Addendum No. 1

RE: Contract # C203825

Jackson County (R-4753)

NC-107 From North Of SR-1002 To NC-281

PROJECT REFERENCE NO. R-4753		SHEET NO. 9	
ROADWAY DESIGN ENGINEER DAVID J. CLARK, PE 035683		HYDRAULICS ENGINEER STEPHEN R. MORGAN, PE 02200

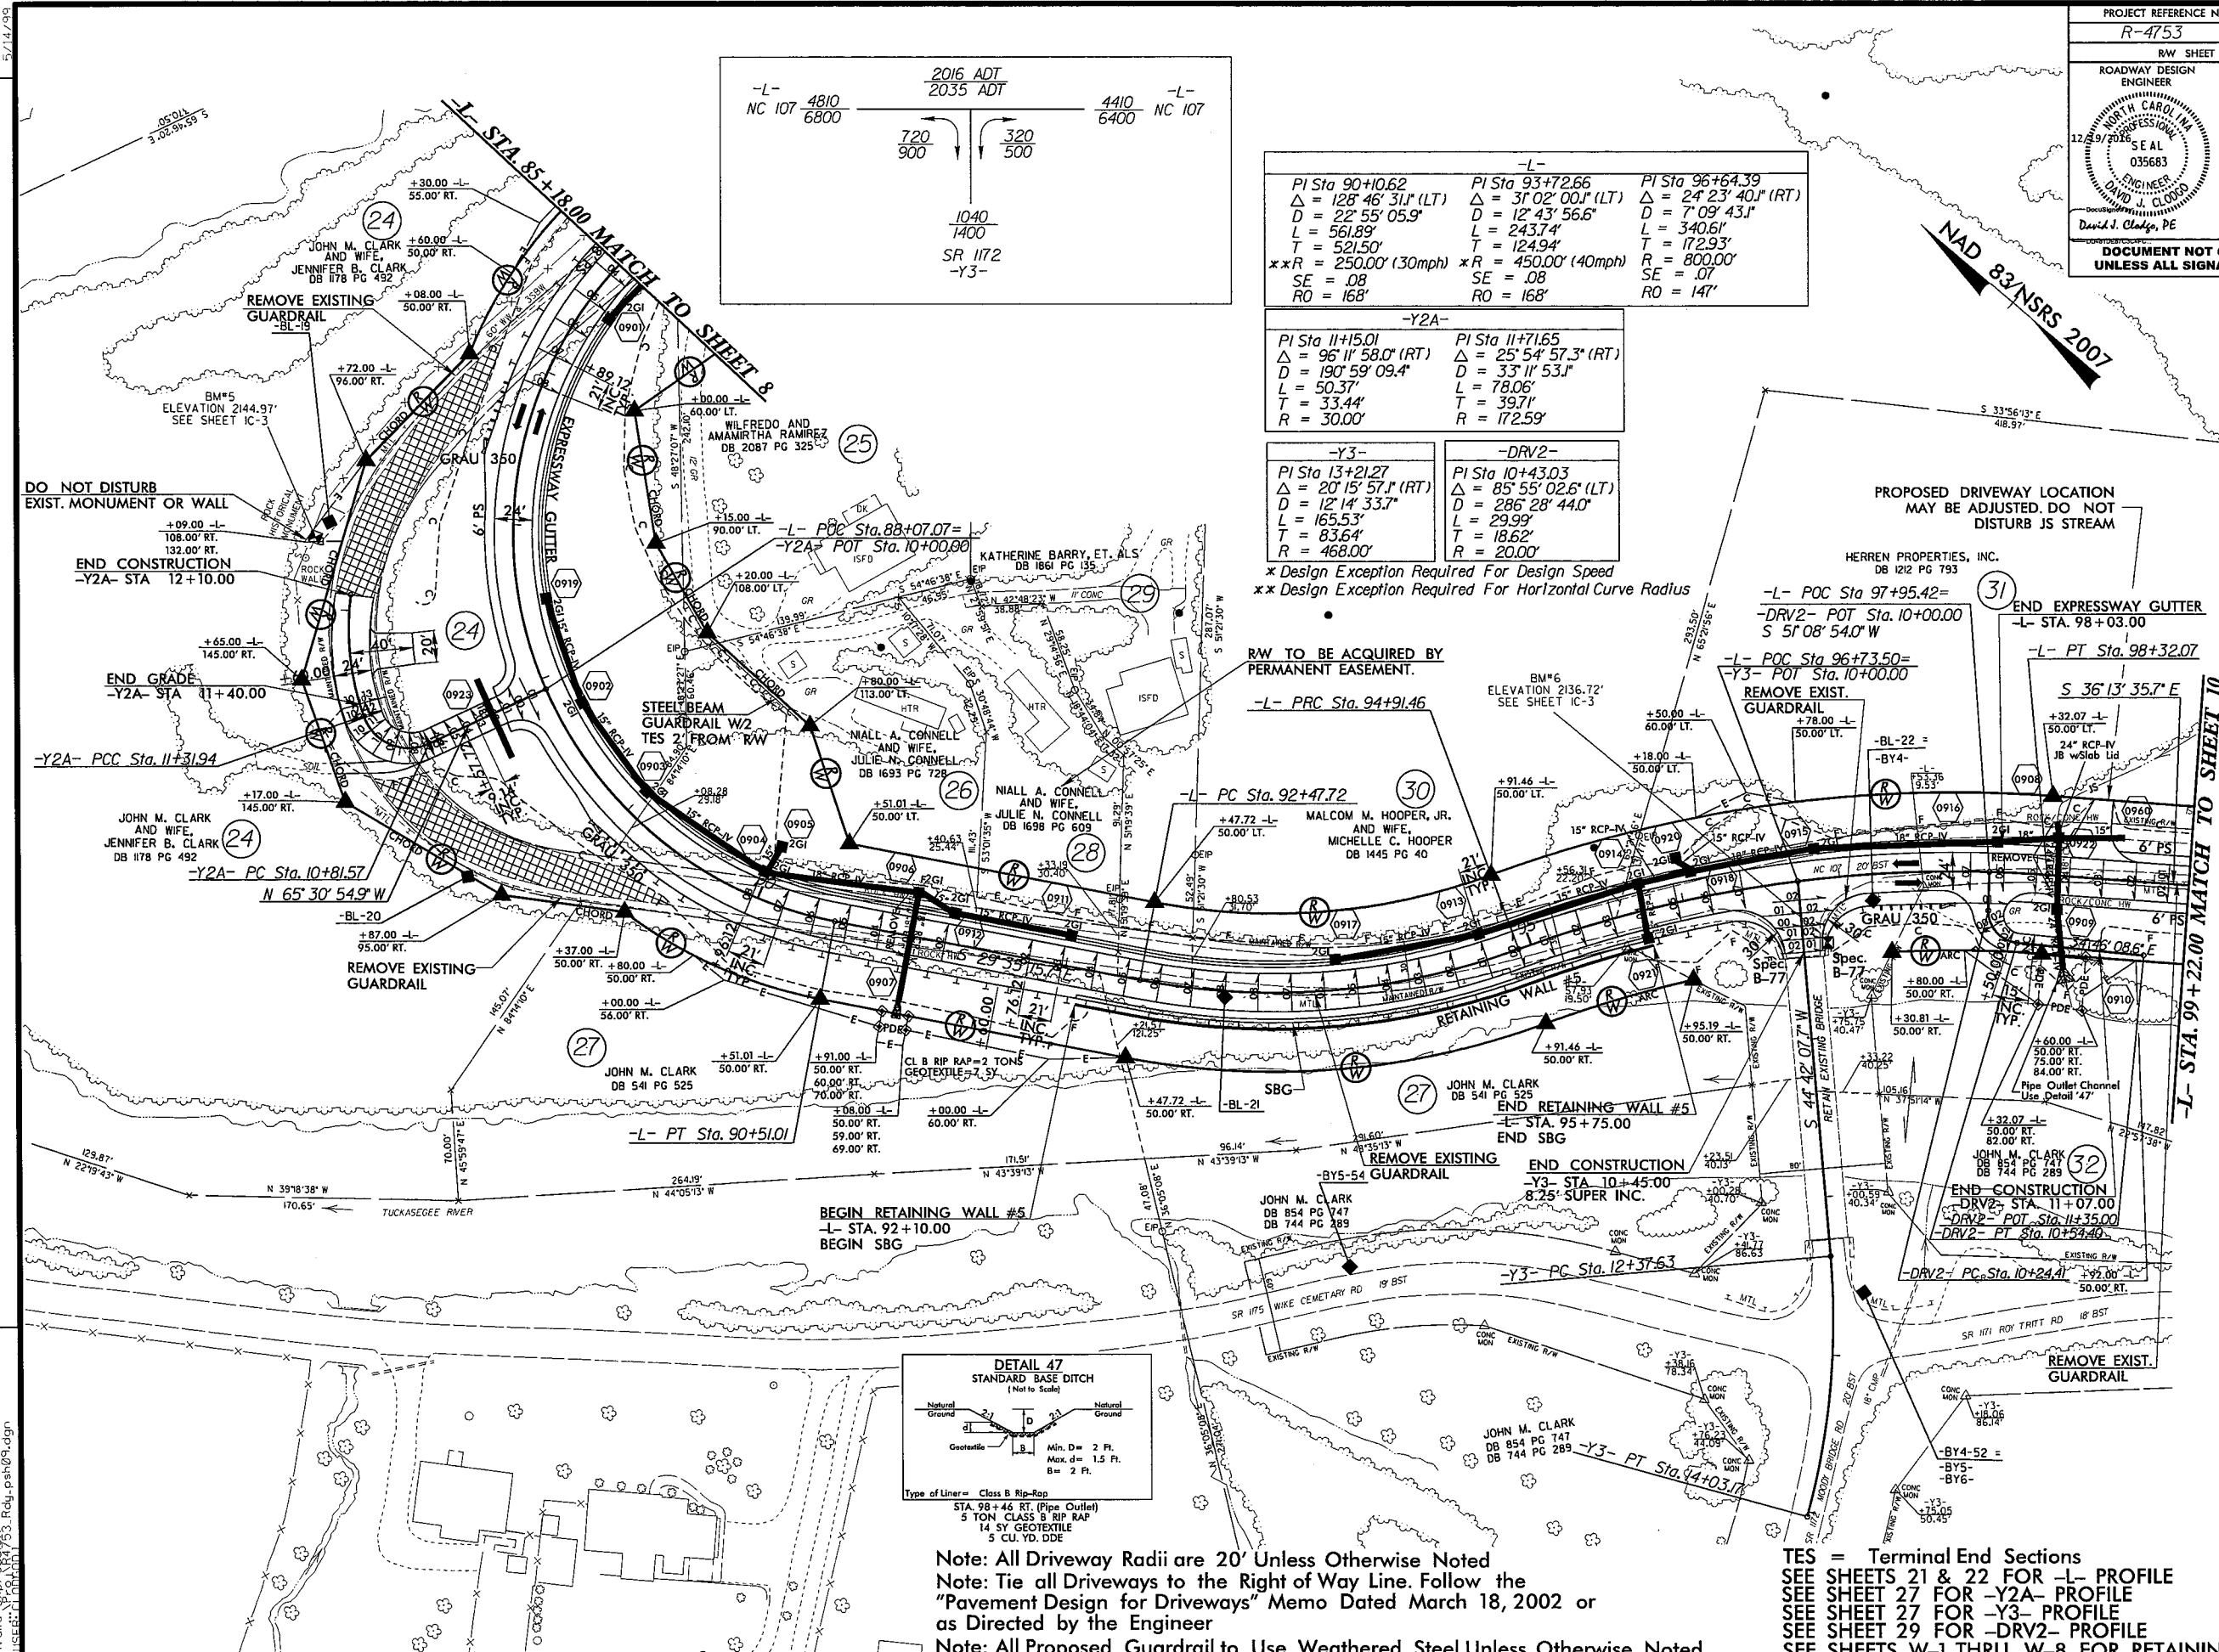
Sheet No.	Revisions
1	Revised the letting date on the Title Sheet
8, 9, 11, 12, 19 and 25	Revised or added a design exception note

* Design Exception Required For Design Speed
 ** Design Exception Required For Horizontal Curve Radius
